SUBJECT: ZION NUCLEAR POWER STATION, UNITS 1 AND 2 - REQUEST FOR
ADDITIONAL INFORMATION RELATED TO PARTIAL SITE RELEASE AND
RECENT SITE SURVEY ACTIVITIES (EPID L-2020-DSR-0000)

REQUEST FOR ADDITIONAL INFORMATION

ZION NUCLEAR POWER STATION, UNITS 1 AND 2

Figure 1 - Suspected Particle Locations (Figure A.8 in ORISE Report)

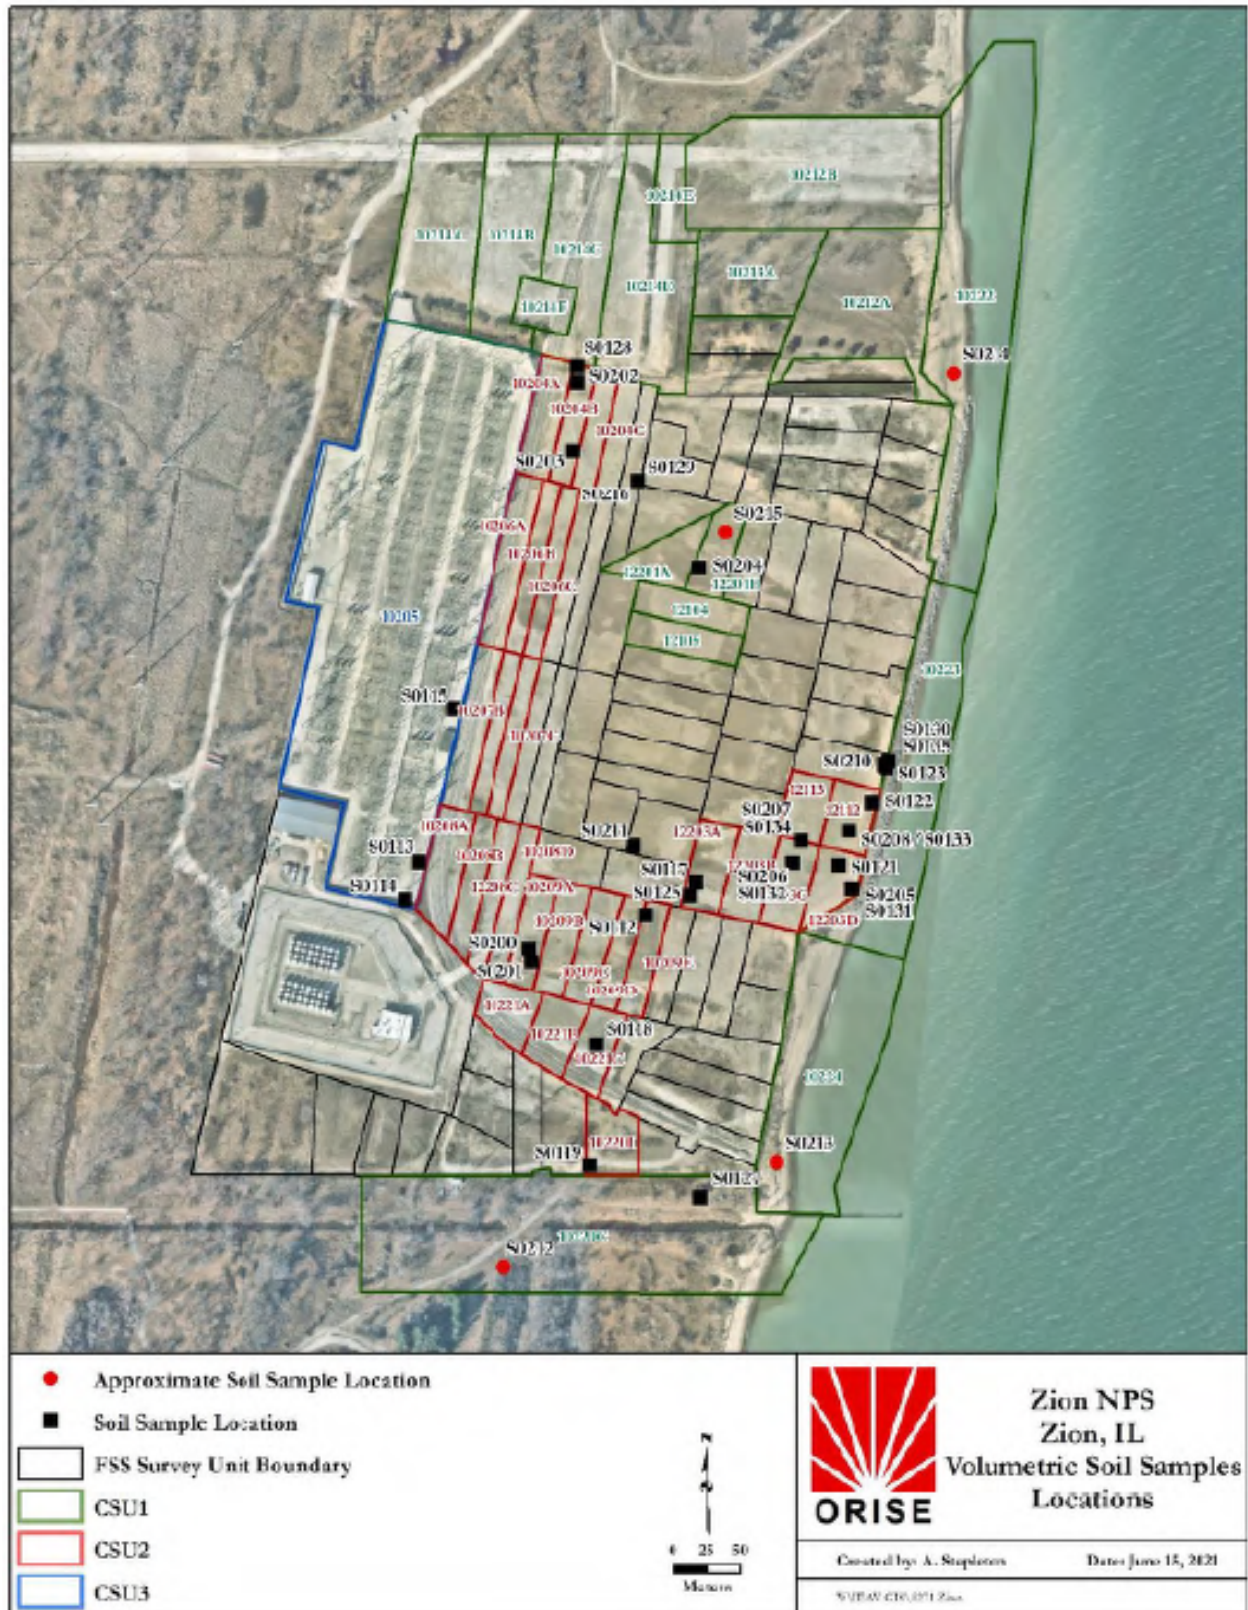
Some of the April 2021 inspection survey observations (for example: Samples S0124, S0203, S0126, S0120, and S0204AEu) may indicate to ensure that the scan sensitivity implemented during FSS was inadequate to detect certain radionuclides that are present at the ZNPS site. It was also determined that the licensee had not sampled and analyzed for certain hard-to-detect radionuclides (i.e., americium-241 (Am-241) and other transuranic radionuclides collected at the land surface). Without knowing the specific radionuclides that were present on the land surface, the licensee could not design a survey program that could adequately detect and quantify the radioactivity in the ZNPS land areas.

For ease of reference, Figure A.8 and Figure A.9 from the ORISE report are reproduced below to show the locations of the suspected and confirmed particles within the ZNPS survey units (SUs), as well as the judgmental soil sample locations from the April 2021 inspection survey.

**Figure 4 - SUs Associated with the Power Block Subject to Confirmatory Surveys
(Figure 3.1 in ORISE Survey Report 5271-SR-07)**

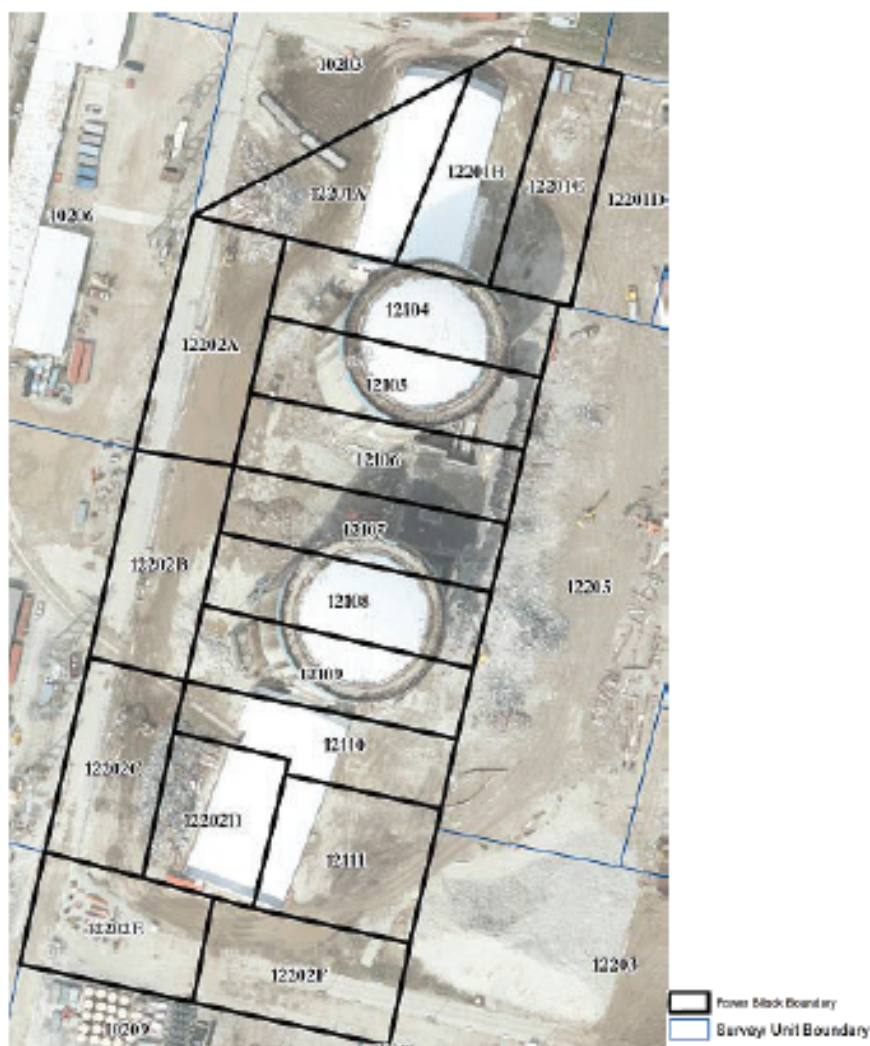
Comment: Observations from the April 2021 inspection survey are indicative that the thickness of clean cover in certain areas of the site are not consistent with the Zion LTP commitments, the assumptions for deriving the basement DCGLs, and the description of the end state of the site included in Phase 4 of the Zion FSSR. Information is needed by the NRC staff to verify that the cover material is consistent with the assumptions included in the Zion LTP and the final site description in Phase 4 of the Zion FSSR.

Figure 4 below, reproduced from the ORISE Survey Report (5271-SR-07 Zion Sacrificial Sub-Soil), shows the SUs with 588-foot indigenous soils that received confirmatory survey in August 2019. Note that SU 12201B is located directly north of the Zion Unit 2 containment.

- b. For the areas of the site directly above backfilled basement structures (including the ZNPS Crib House basement in SU 12204), verify that the thickness of the clean cover material between the land surface and the upper level of the basement fill material is consistent with the Zion LTP commitments and the description of the site end state in Phase 4 of the Zion FSSR.

Figure 5 – The Three Class 1 Open Land Survey Units Created from Class 2 Survey Unit 12204 (Figure 2 in the FSS Release Record for SU 12204C in the Phase 3 FSSR)

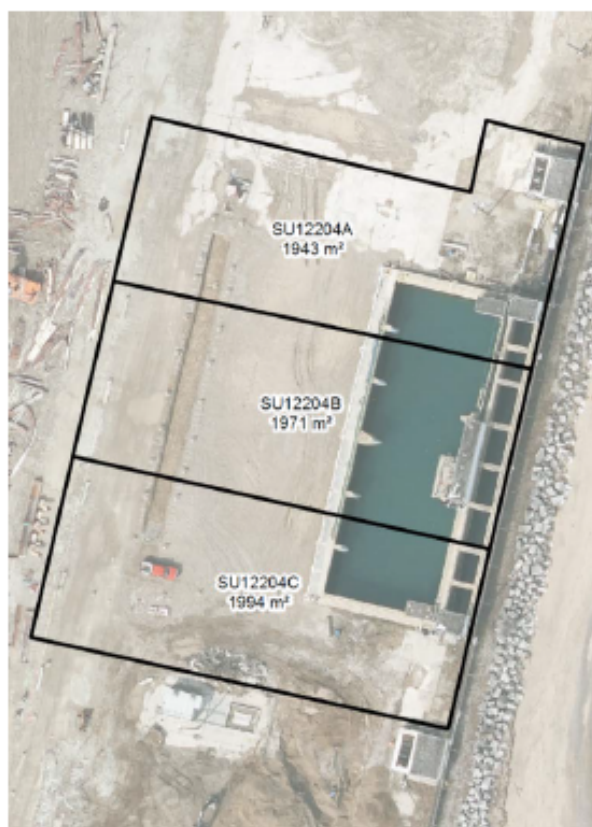
When performing [Radiological Environmental Monitoring Program Thermoluminescent dosimeter] REMP TLD change on 12/29/19 noted erosion in two areas 200-300 yards south of the old Forebay in [SU] 12204C. See two attached pictures. One picture shows approximate 2 foot deep crevice with over 8 foot uncovered timber. Second area near timber is another crevice with large exposed boulder, 2 inch pipe and rebar sticking up from eroded area.

Further observations and samples collected during the April 2021 inspection survey also call into question the thickness of the clean cover material in the final Zion site configuration. For example, limited samples were collected in April 2021 from the area where erosion was documented in the referenced CR, but some samples that were collected in SU 12204C near the border with SU 12204B and SU 10223 (beach area) contained unexpected radionuclides. Specifically, Sample S0135 and Sample S0130 contained Eu-155. It is unclear why europium is present in this area, as europium indicates activated concrete and is not expected in the Zion soil. It is also unclear if the samples represent backfill material or material that was placed on top of the clean fill material that was used for final site grading.

- c. Justify how current site conditions are consistent with Zion LTP. If the Zion site conditions are not consistent, discuss the intended path forward (e.g., a license amendment to revise the assumptions in the Zion LTP) to resolve the inconsistency.
